## S.4.55 MODIFICATION REPORT

REPLACEMENT OF THE MOUNT PERISHER DOUBLE AND TRIPLE  
CHAIRLIFTS WITH A SIX SEAT DETACHABLE CHAIRLIFT &  
ASSOCIATED WORKS

PERISHER SKI RESORT  
KOSCIUSZKO NATIONAL PARK

**JULY 2024**  
Project: 10-19

*Figure 8: Proposed modified Stage 1 top station elevations*

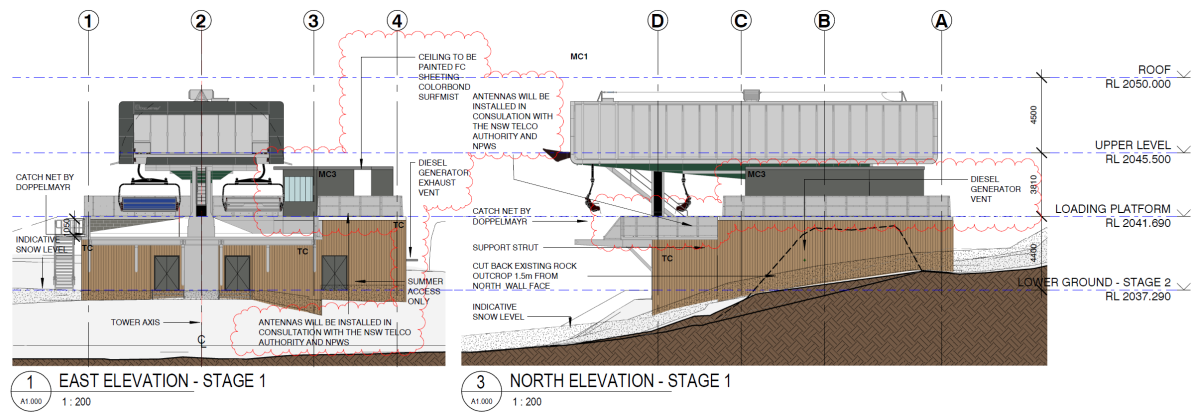
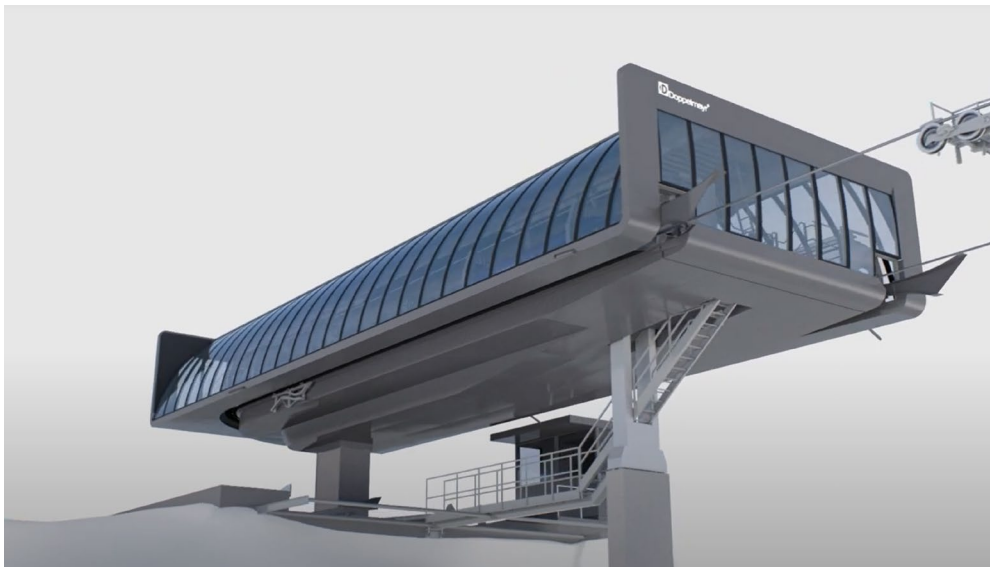
Whilst the lower ground floor will still be constructed, with a slightly modified layout, above the ground floor slab, the D-line standard Doppelmayr structure will be constructed for the 2025 season, allowing for the lift to open and operate. An extract of the modified Stage 1 top station plans is provided below.

With the lower ground floor foundations and slab having been constructed so it can accommodate a future enclosed building, the staging and modified plans will allow Perisher to open and operate the lift without the enclosed building. Should Perisher choose to erect this later, they can do so as Stage 2 for the top station, obtaining a separate Construction Certificate at that time.

- Removal of external steel decking and associated access door at Ground level.
- Rearrangement of control hut space.
- Removal of maintenance area and associated platform.
- Addition of Southern external access stairs.
- Change of finish to Lift control hut to Metal Cladding
- Addition of internal access doors to Lower Ground level spaces.
- Addition of perimeter balustrading to Ground Level.

*Figure 12: Proposed modified Stage 1 bottom station elevations*

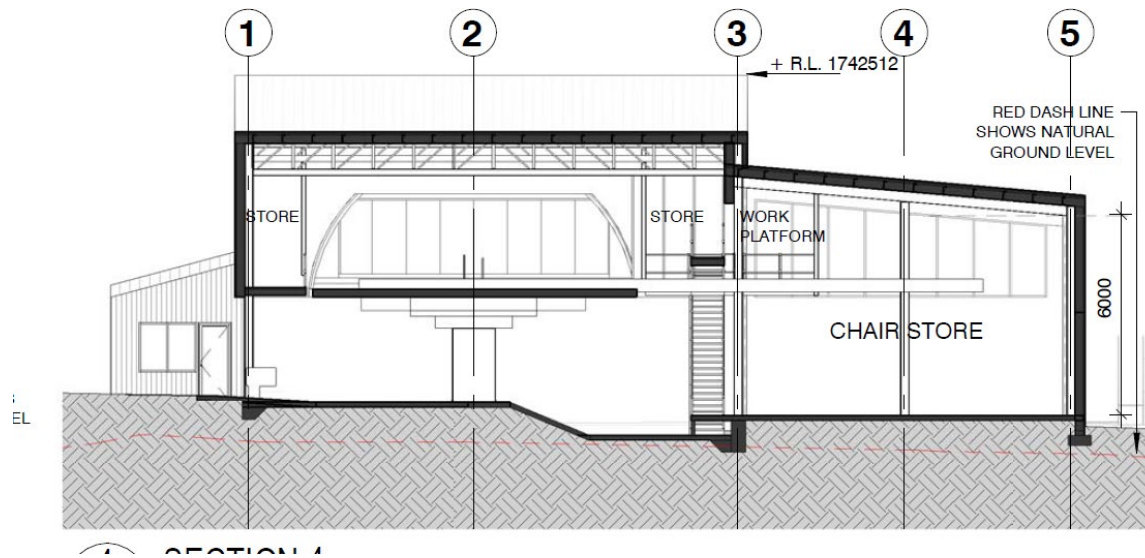
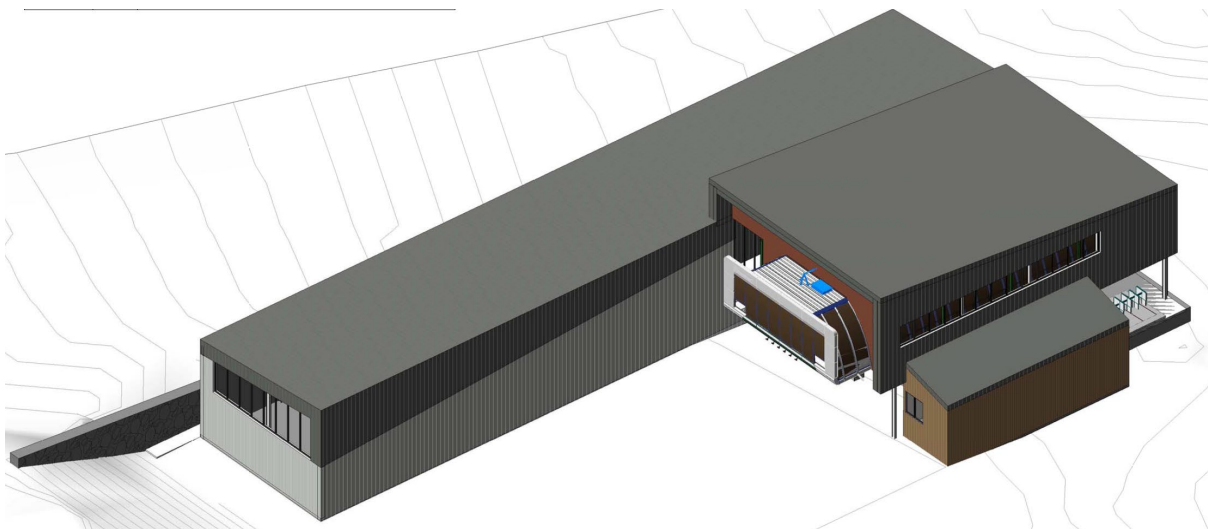
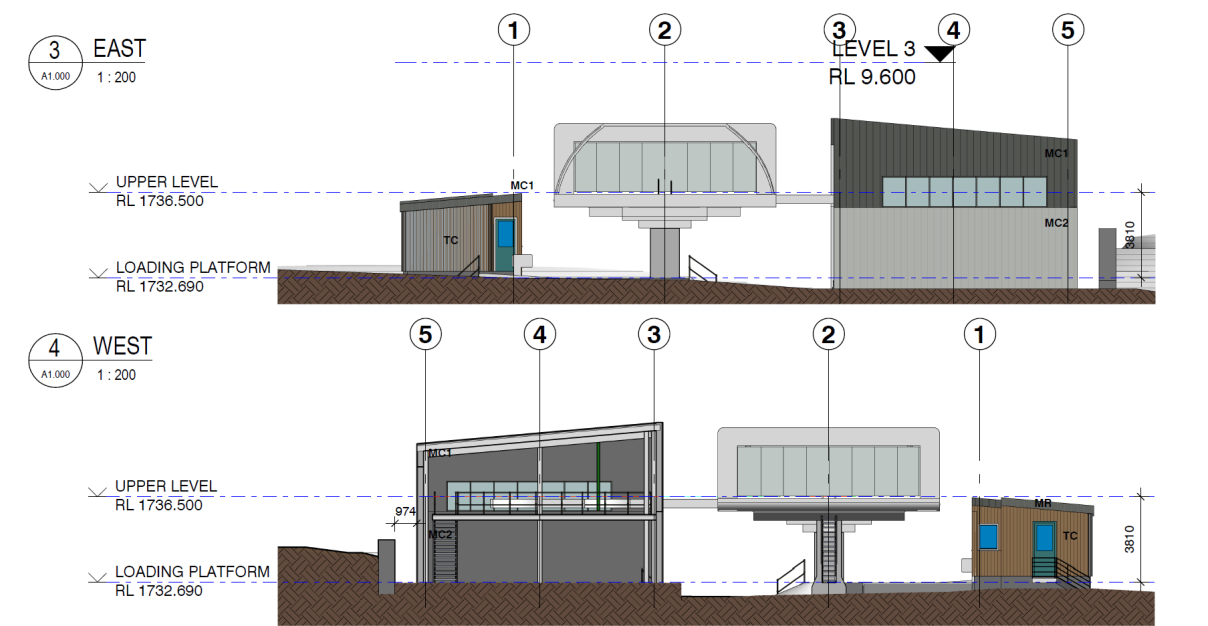
With the lower ground floor foundations and slab still being constructed so it can accommodate a future enclosed building, the staging and modified plans will allow Perisher to open and operate the lift without the enclosed building. Should Perisher choose to erect this later, they can do so as Stage 2 for the bottom station, obtaining a separate Construction Certificate at that time. An extract of the modified Stage 1 bottom station plans is provided below.

- Change of retaining walls from Gabion walls to Beton Blocks.
- Rearrangement of ski chairlift maintenance area to the eastern end of the chair shed store.
- Rearrangement of control hut floor plan with addition of personnel access stairs.
- Change of control hut cladding from timber to metal cladding.
- Addition of personnel access door to chair storage shed.
- Addition of access stairs on path to chair storage shed.
